NWB File No.: 2AM-MEL1631

**Re: Response to Comments to 2AM-MEL1631 Water Licence Amendment – Operational Update
– Information Requests / Completeness Check**

Figure 5-4: Annual EWTP discharges to Meliadine Lake. Maximum allowable annual discharge volume shown by orange line.

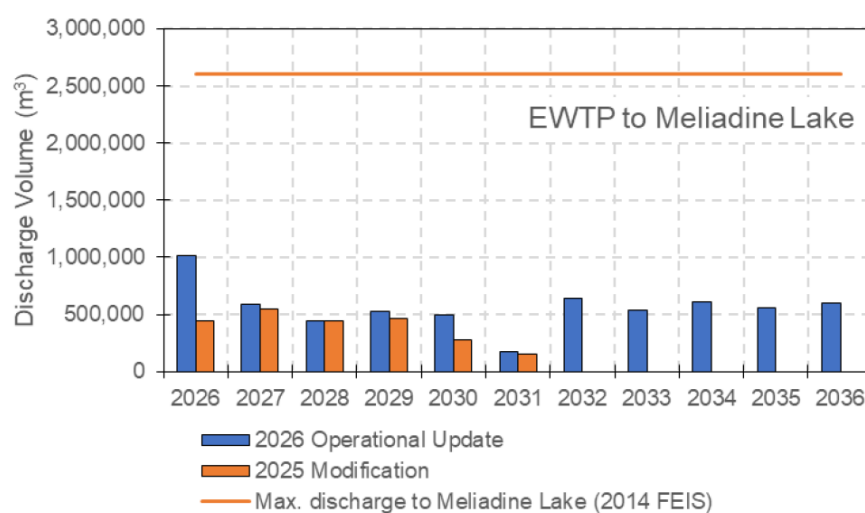
CIRNAC recommends that Agnico Eagle review its distribution of waterline input, or other options, to further reduce or eliminate the ~580 000 m³/year annual discharge to Meliadine Lake currently proposed.

Agnico Eagle engaged with the Kivalliq Inuit Association to review the Water Balance Water Quality Model (WBWQM) results for this Water Licence Amendment (prior to the submission to the NWB), with full consideration of the Adaptive Management Plan commitment that *"Agnico Eagle shall minimize or eliminate surface contact water discharges to Meliadine Lake by discharging on-site surface contact water in accordance with the Groundwater Management Plan and/or Adaptive Management Plan."* The WBWQM included with this application also considered Part F, Item 4 of Water Licence 2AM-MEL1631, which requires discharges from the Final Discharge Point (MEL-14) to Meliadine Lake to be minimized to the greatest extent practicable and not exceed the authorized annual volume of 2.6 million m³.

The model results indicate that predicted discharges to Meliadine Lake remain consistent with those presented in the 2025 Modification Application (see figure below, Appendix 4-C). Also described throughout the Water Management Plan (Appendix 5-R) and WBWQM (Appendix 4-C), the objective is to minimize discharges to Meliadine Lake by optimizing discharge of surface contact water via the Waterline to Itivia Harbour; however, the primary purpose of the waterline is for discharge of saline water to the marine environment with the intent to reduce the inventory to zero (or near zero) by the end of the open-water season (or by the end of the yearly operational window of the waterline).

Figure 5-21: Modeled daily volume (top) and water level (bottom) of Meliadine Lake. The Active Closure phase is highlighted.

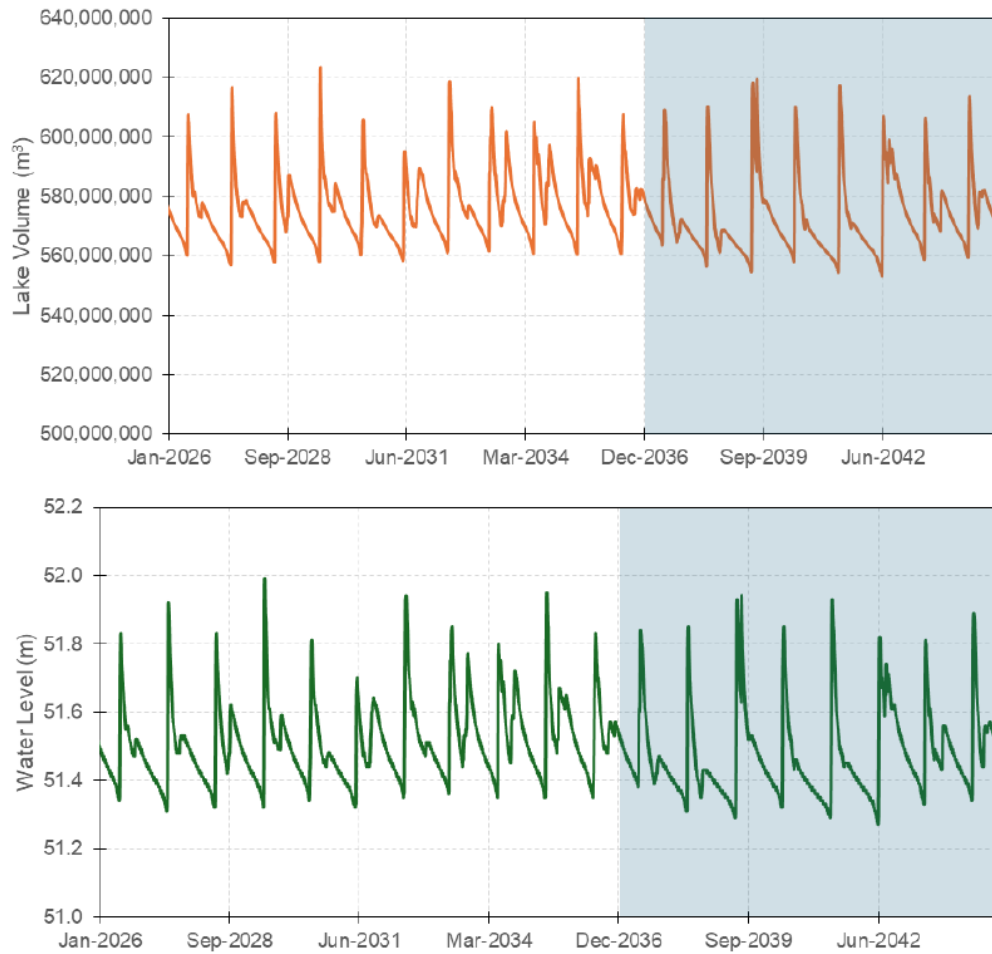
DFO requests that the applicant provide a conceptual plan for the back-flooding of pits as described in the Interim Closure and Reclamation Plan, including proposed flooding rate, duration of flooding, time of year, etc. This back-flooding Plan should include a discussion of potential downstream impacts to fish and fish habitat, as well as a response framework and action levels, as described in DFO-IR-05.

This information is necessary to understand the potential impacts on fish and fish habitat from water withdrawal activity required for the back-flooding of the pit during closure when significantly more water use is required. This activity constitutes a significant volume of water use from Meliadine Lake with potential to impact flows in the Meliadine River and Diane River and poses a high risk to the viability of Arctic char movement through these rivers. As such, it is important to plan well in advance and establish reliable mitigation measures and response framework procedures.

Water withdrawals from Meliadine Lake for pit back-flooding are anticipated to occur during the open-water season (approximately June 15 to September 30). The active closure pumping schedule remains flexible and will be managed to control withdrawal rates and minimize effects on Meliadine Lake.

Also stated in Section 5.5 of Appendix 4-C, withdrawal of water from Meliadine Lake to flood the pits is predicted to result in minimal changes to the lake volume or minimum water levels (see figure below extracted from Appendix 4-C).
